ESTATES AT CATHEDRAL PINES

TYPICAL SECTIONS

### STORM SEWER AND POND PLANS

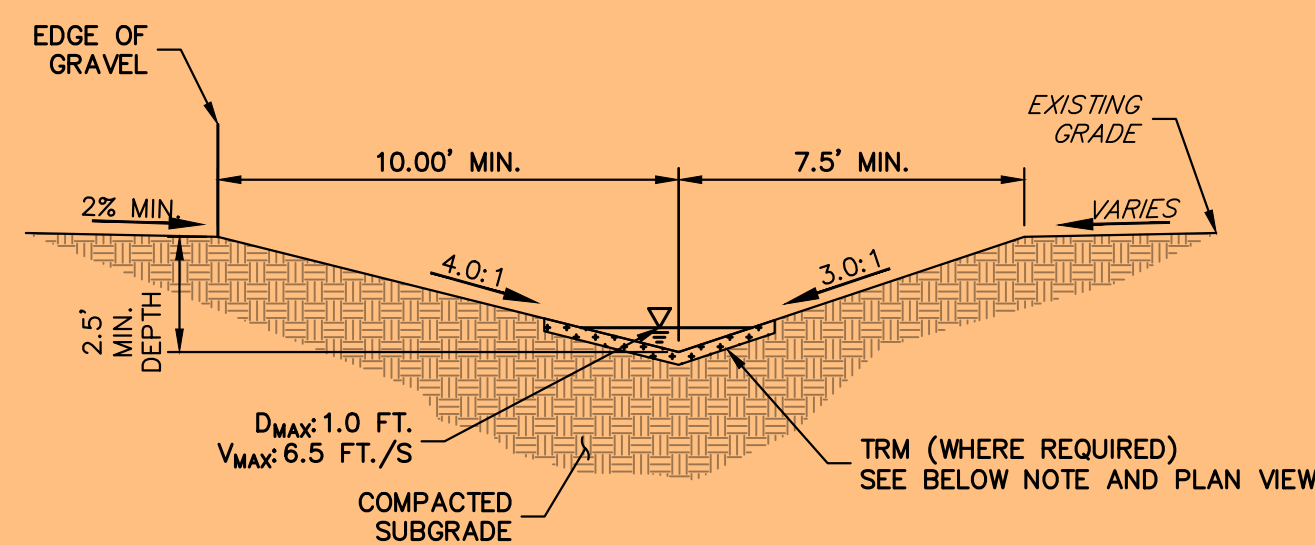
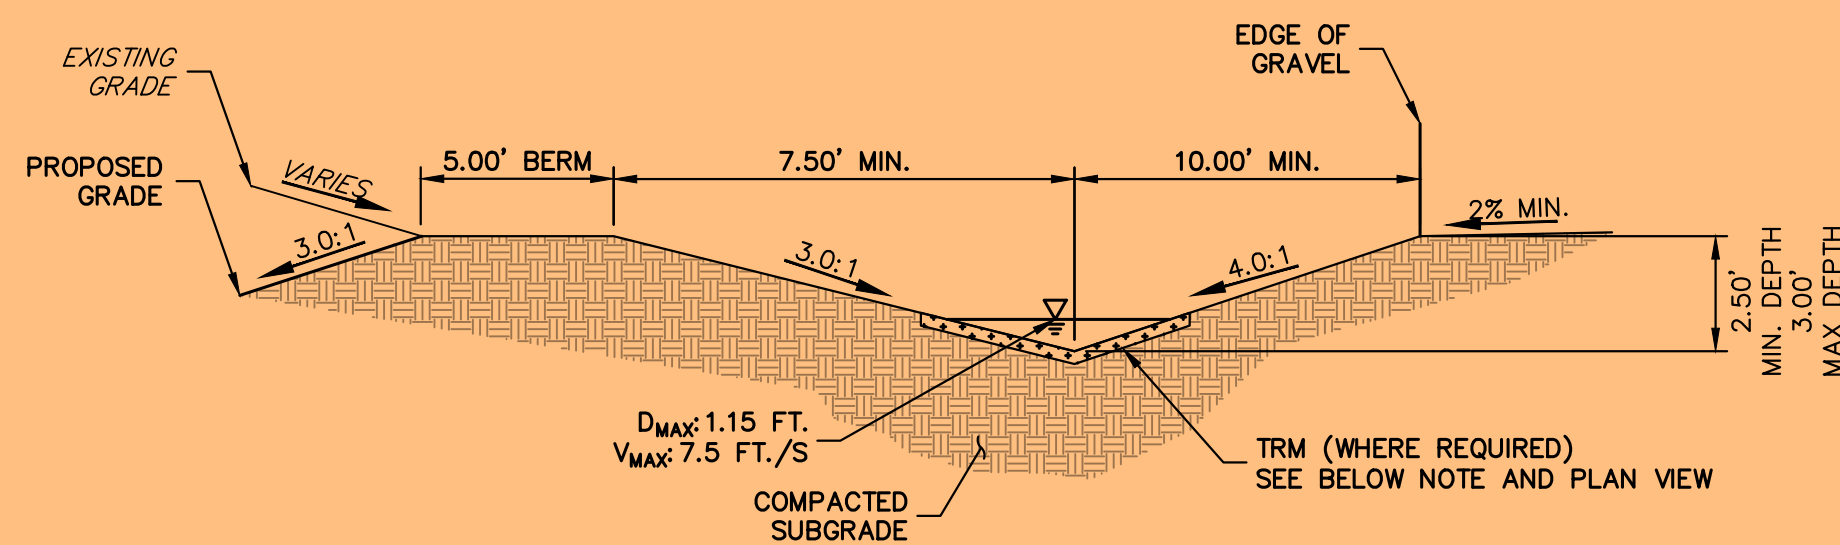
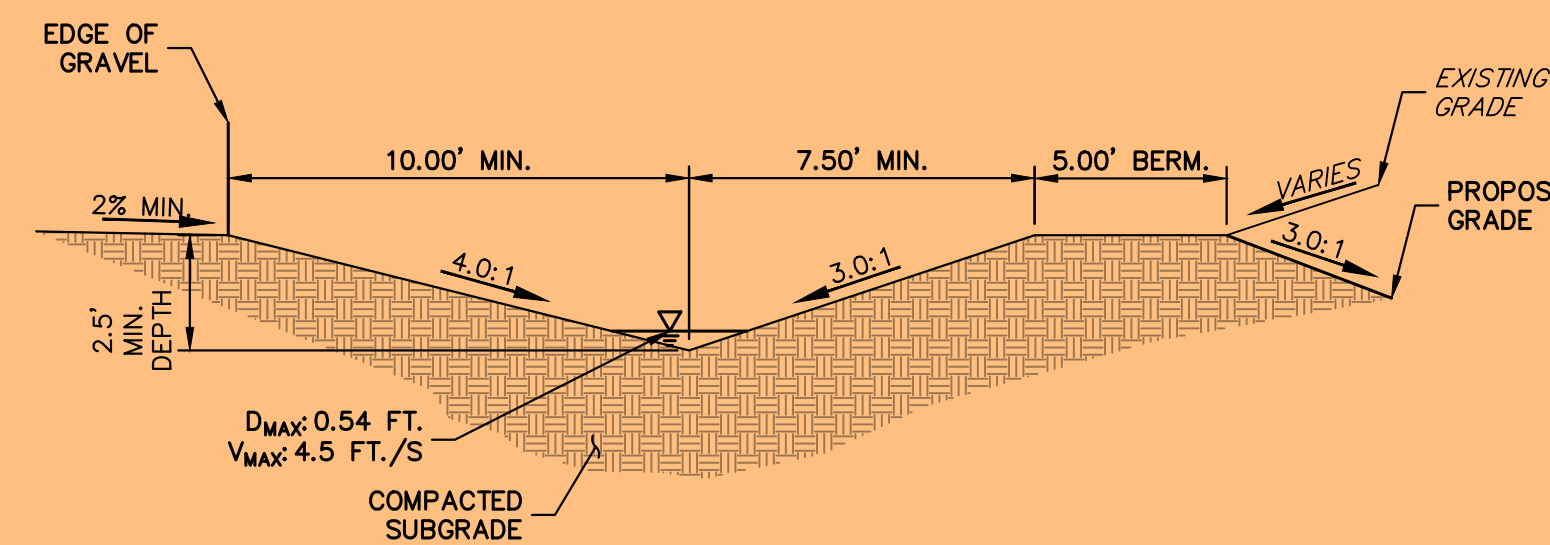
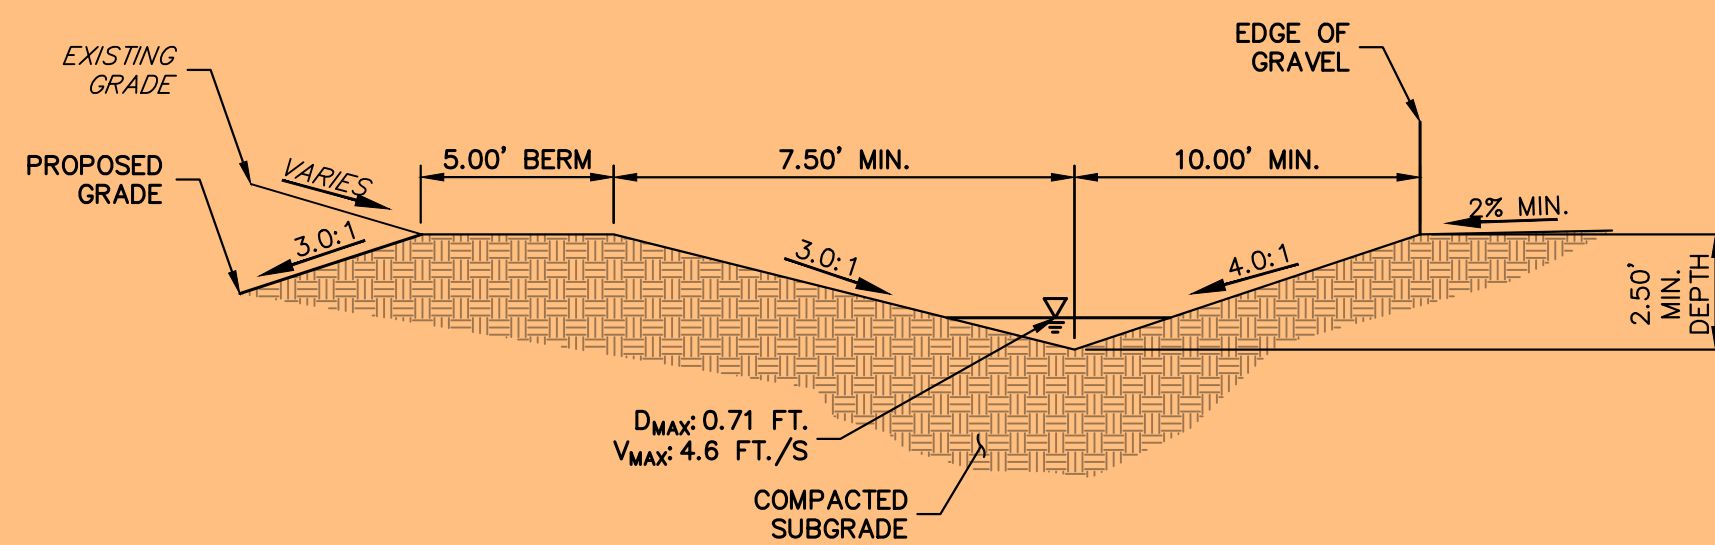
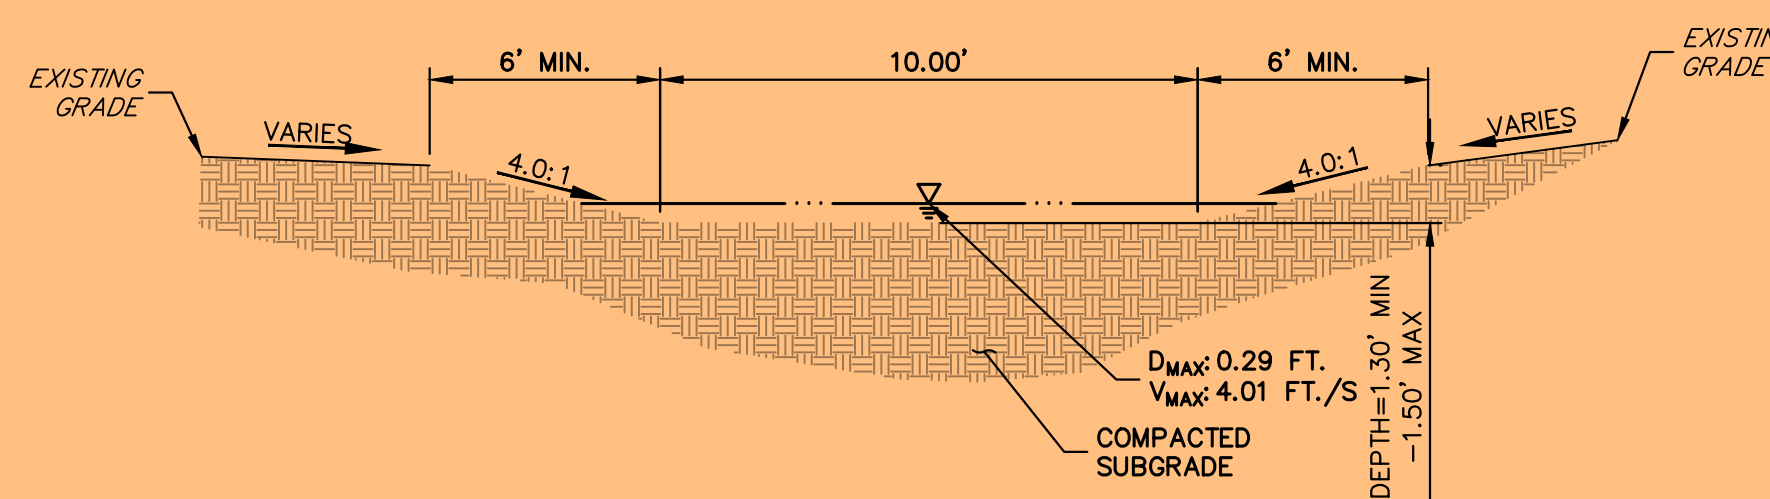
These don't match the V2 GEC Plan swale sections. Update and ensure the swale sections from both plans match.

**TRASH SCREEN AND PLATE DETAIL (PLAN)**

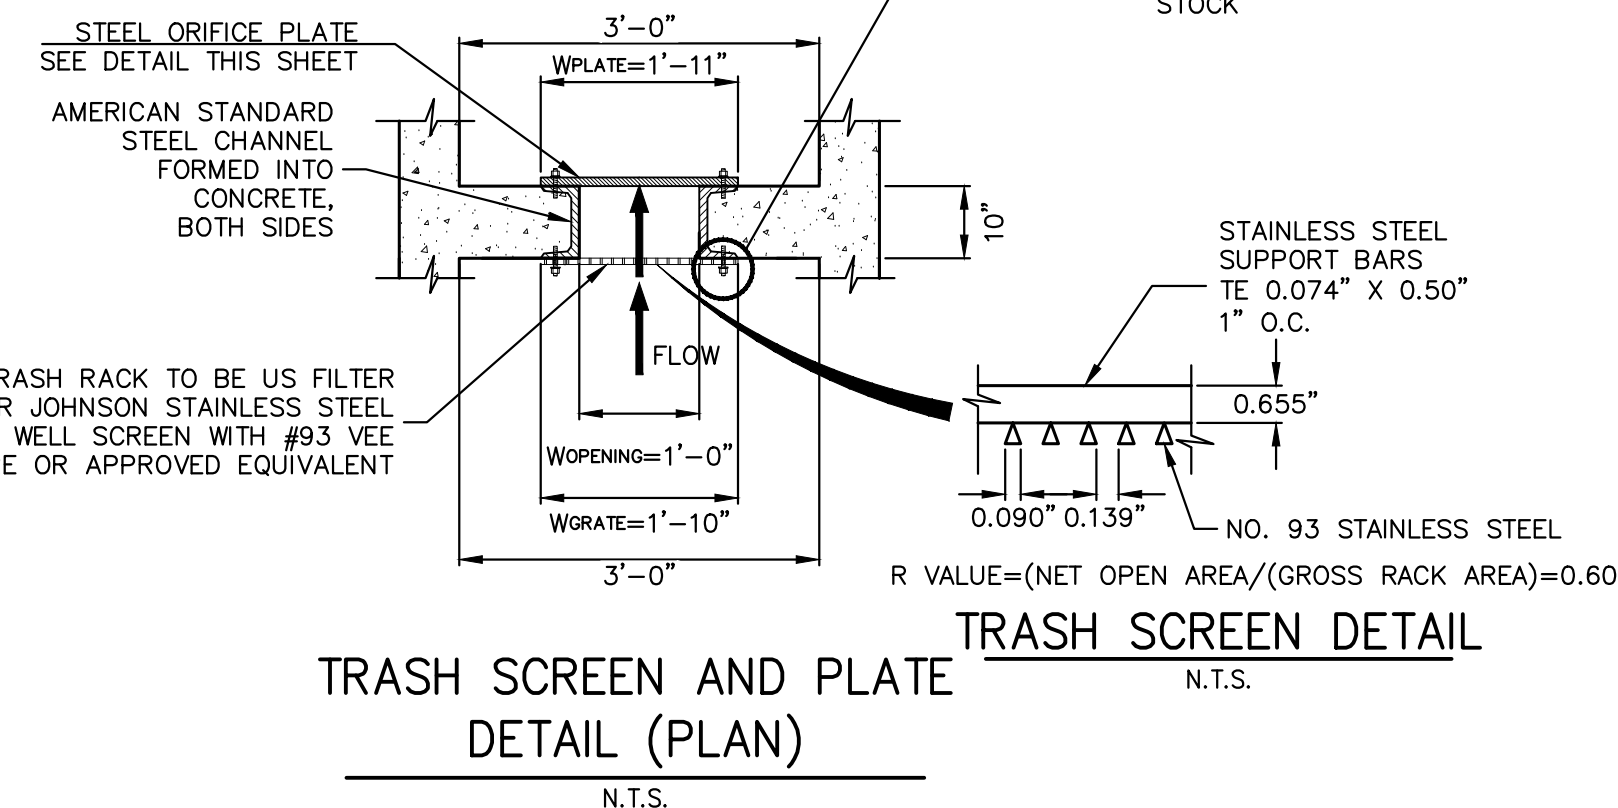
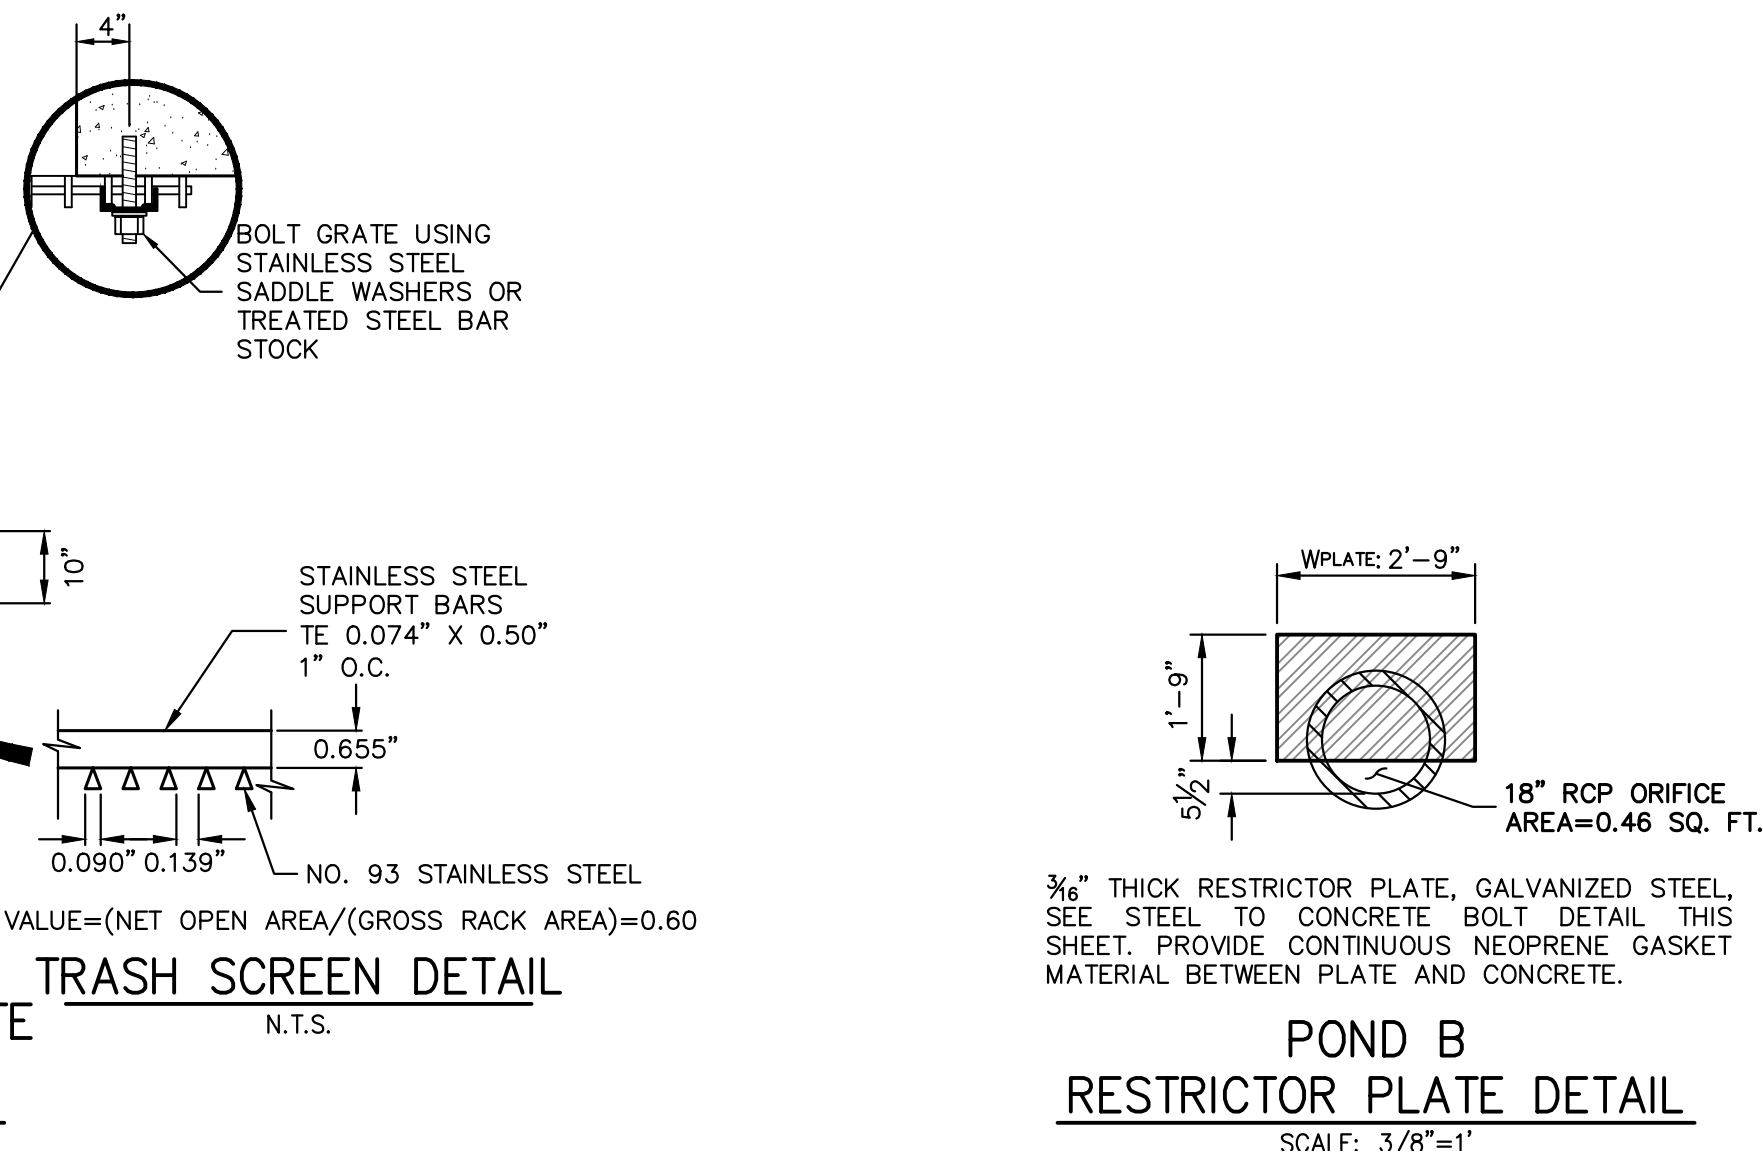
Please remove the flow fill. The flow fill will interfere with the orifice plate function.

The fill will have more potential to impair the outlet structure so it is okay to construct without the 2.5% slope. Disregard previous comment.
